RE: ROUND UP LAKE
FORMERLY JELLYSTONE PARK
PERMIT NO. 3PR00090*ED
PORTAGE COUNTY
MANTUA TOWNSHIP

On August 29, 2013, an inspection of the above referenced facility's wastewater treatment system was conducted. The facility was represented by Mr. Mark Rhoades, Class "A" Waste Water Treatment Plant Operator. The purpose of the inspection was to: (1) evaluate the performance of the wastewater treatment system along with the facility's compliance status with respect to the terms and conditions of the above-referenced National Pollutant Discharge Elimination System (NPDES) permit and (2) determine required additional actions to be undertaken as part of the permit renewal process.

Figure 1

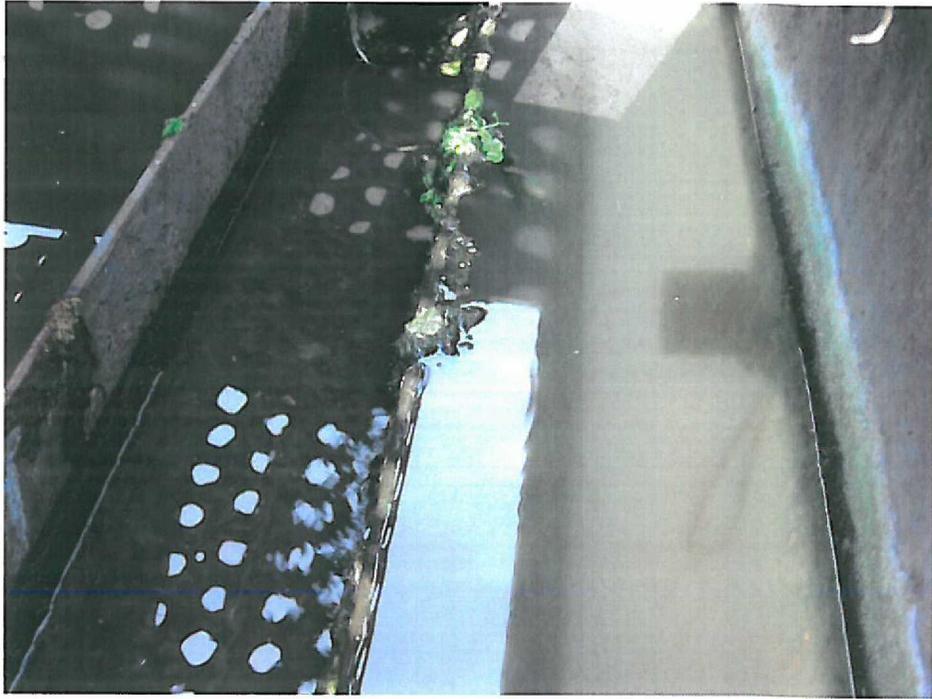
25. The weirs and trough in the settling tank were covered with vegetation and moss. See Figure 1. The weirs and trough should be scraped down or hosed off on a regular basis.
